RAAF ADDITION SEDGWICK COUNTY, KANSAS

S/D 98-46 - Revised One-Step Final Plat of RAAF ADDITION

STAFF REPORT

CASE NUMBER: S/D 98-46 - RAAF ADDITION

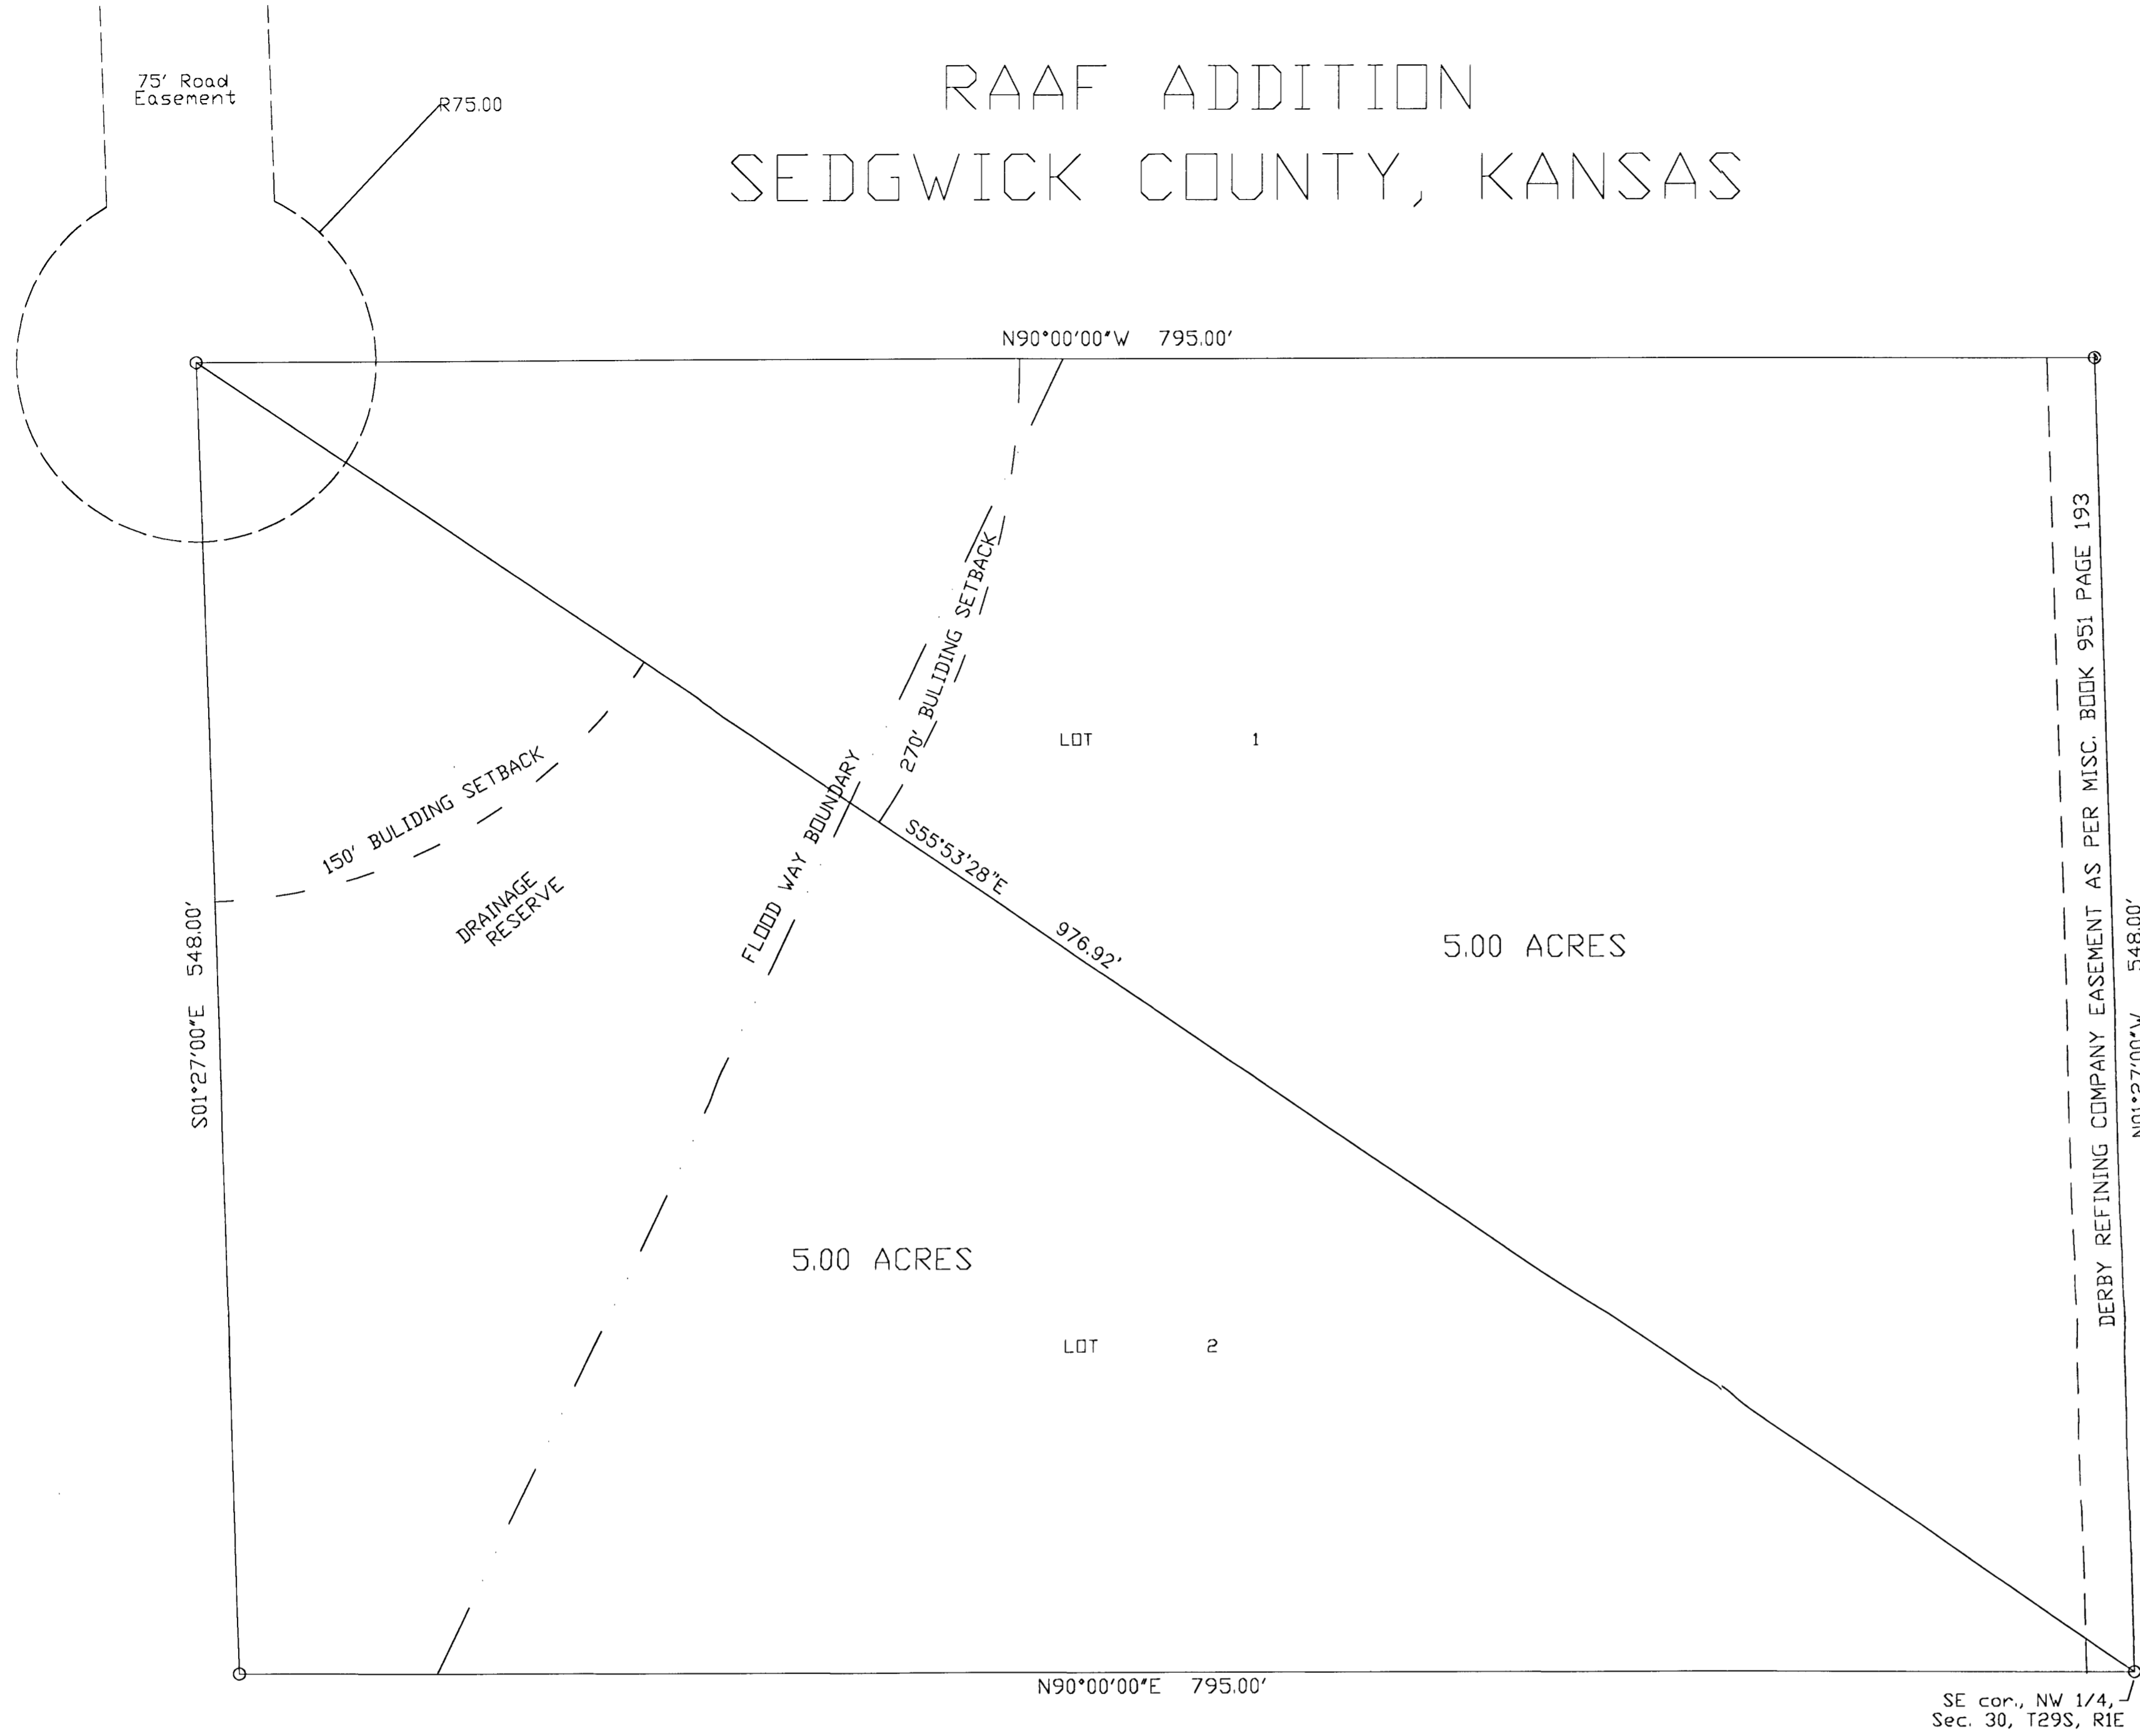
- E. The platting binder indicates two pipeline easements which are not denoted on the plat. Verification must be provided by the pipeline companies that both pipeline easements are located off-site or have been released.

- F. Lot 1 does not conform with the 200-foot lot width requirement of the RR district. An increase in the distance of the building setback from the road would enable the lot to meet the standard.

- G. The dimension for the west line of the plat does not correlate with the legal description and should be corrected on the final tracing.
- H. The applicant shall install or guarantee the installation of all utilities and facilities which are applicable and described in Article 8 of the MAPC Subdivision Regulations. (Water service and fire hydrants required by Article 8 for fire protection shall be as per the direction and approval of the Chief of the Fire Department.)

- E. The platting binder indicates two pipeline easements which are not denoted on the plat. Verification must be provided by the pipeline companies that both pipeline easements are located off-site or have been released.

- F. Lot 1 does not conform with the 200-foot lot width requirement of the RR district. An increase in the distance of the building setback from the road would enable the lot to meet the standard.

- G. The dimension for the west line of the plat does not correlate with the legal description and should be corrected on the final tracing.

Q. The names in the signature blocks for of the Register of Deeds and the Deputy should be corrected to read, "Bill Meek" and "Linda Kizzire".
